Peer Review: East Village Urban Design Report

Client: Victorian Planning Authority

The Victorian Planning Authority has engaged AECOM to prepare a peer review of the Conceptual Master Plan East Village Urban Design Report (Draft – November 2017) prepared by MGS Architects (referred to as the ‘Report’). The purpose of this review is to:

Figure 4. Housing Context

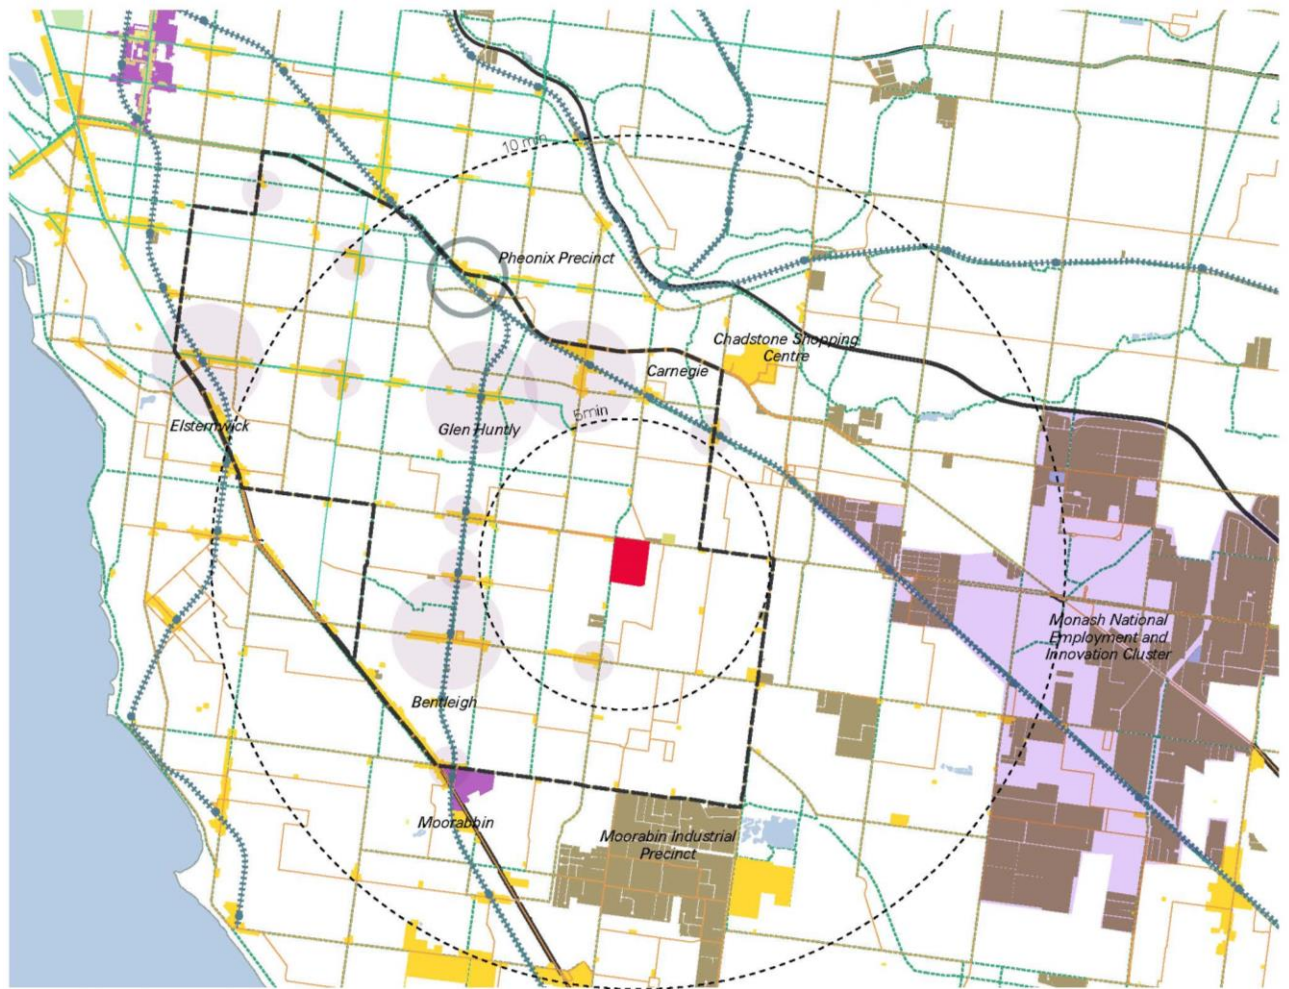
Strategic Map from Report – Travel times are not labelled as to which transport mode they denote.

1. The strategic movement and transport context of the precinct should be more thorough, which would assist in providing a stronger rationale for the value and benefit of substantially intensifying development in this location. This should include:
 - the existing local residential walking catchment to future, significant retail and employment land uses on the site (approximately 18,000* residents within a 1km walking distance),
 - the key employment and education hubs that lie within an easy cycling distance (especially where they are along existing or proposed, dedicated cycling routes, and
 - Connections to other retail, employment, education and community services.
2. The term 'enterprise precincts' should be more well-defined with local examples, and/or example not dependent on heavy rail transport provision

Figure 27. Existing Building Heights

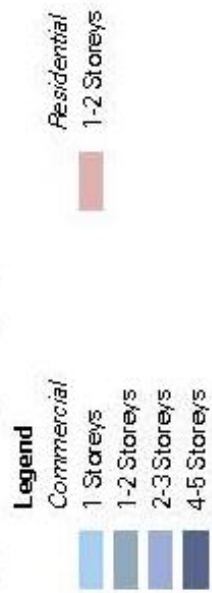
The Existing Building Heights and Existing DPO Height Limits are used as the justification for the proposed heights and setbacks.

10. A comprehensive built form analysis should be provided and follow a coherent methodology that should include:

- Existing character,
- A precinct vision,
- A design response diagram,
- A concept masterplan,
- Urban design principles, and
- Land use and sub-precincts.

Figure 29. Proposed Building Heights Map (Indicative)

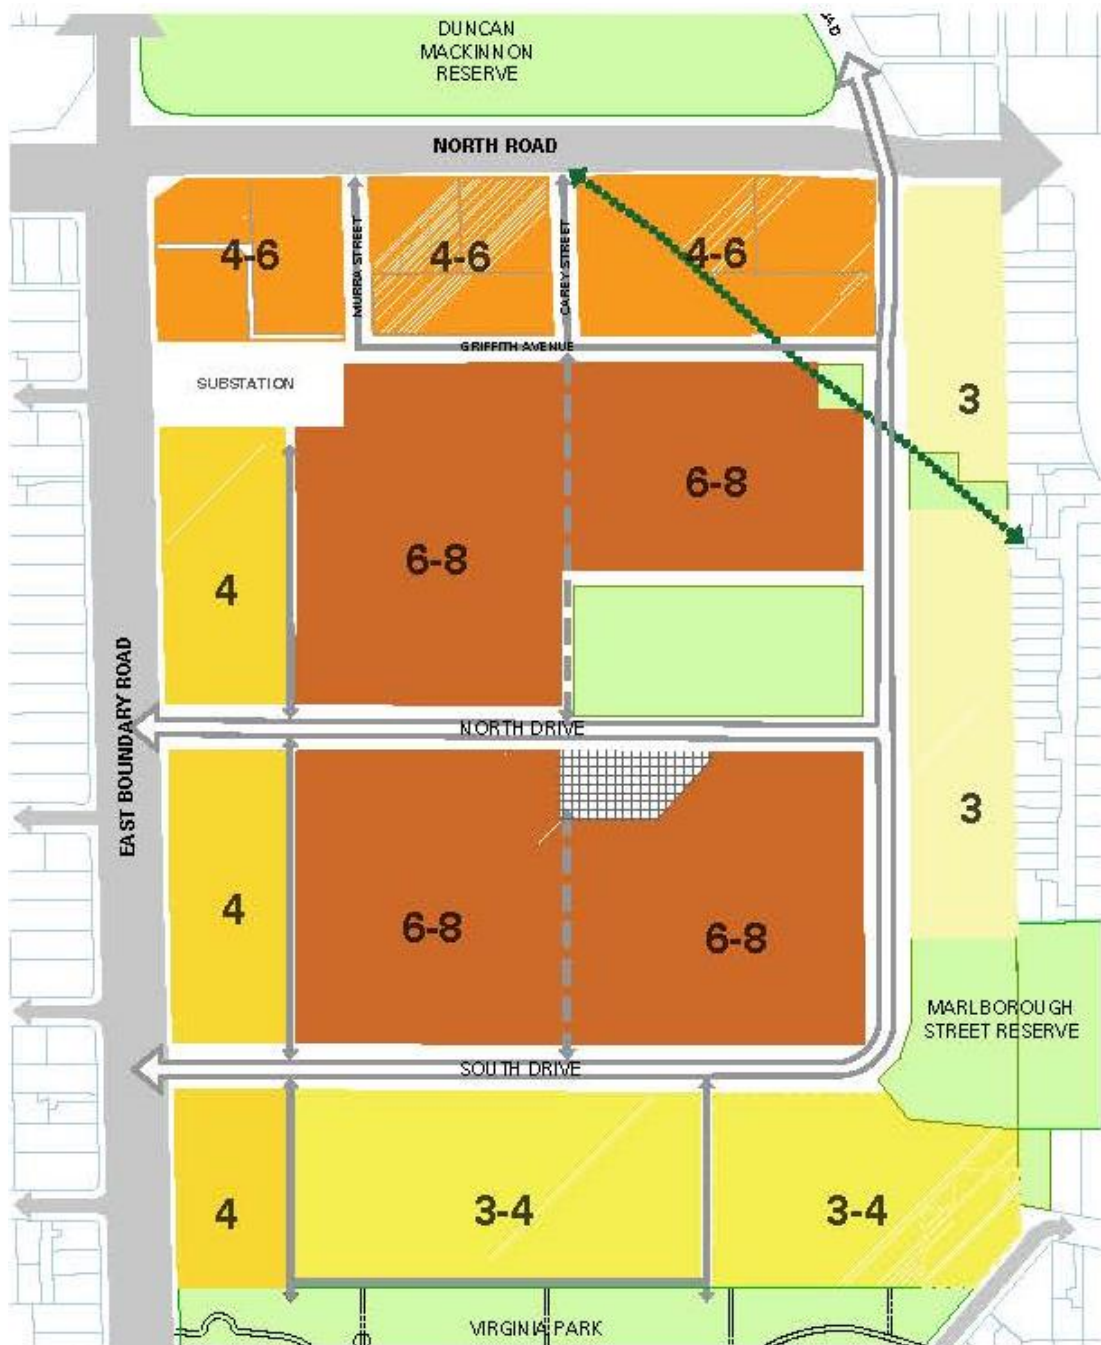
The Proposed Building Height Plan is introduced with no other discussion, justification or explanation regarding street, open space, land use or built form arrangement for the Precinct.

Figure 36. External Interface Map

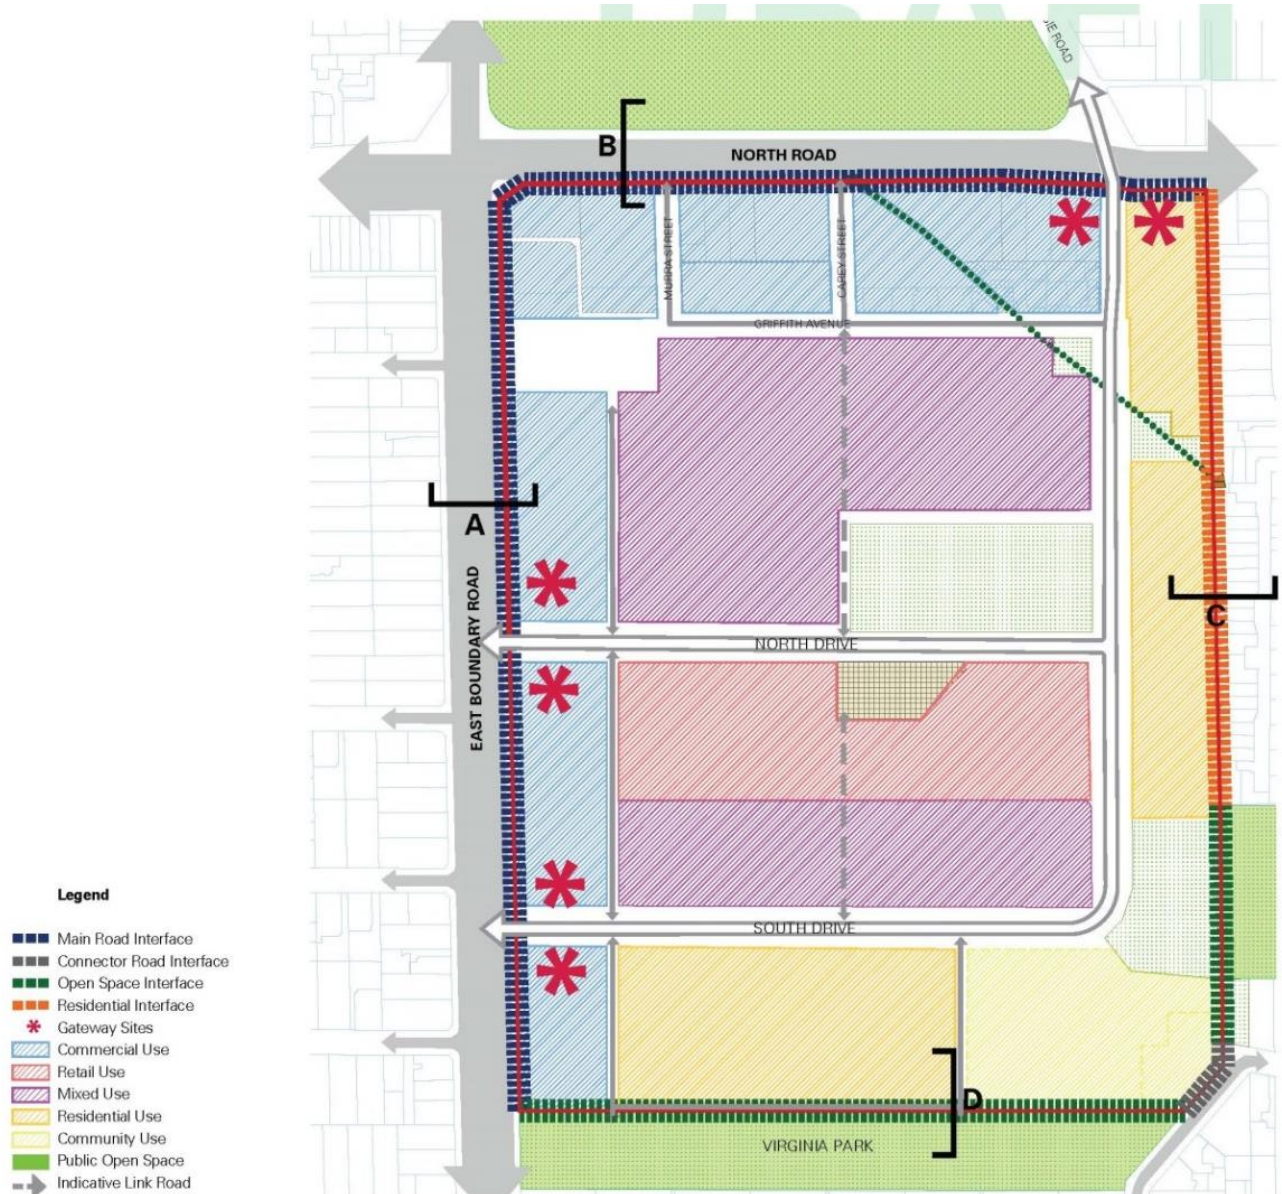
The External Interface Map introduces proposed land uses within the Precinct for the first time.
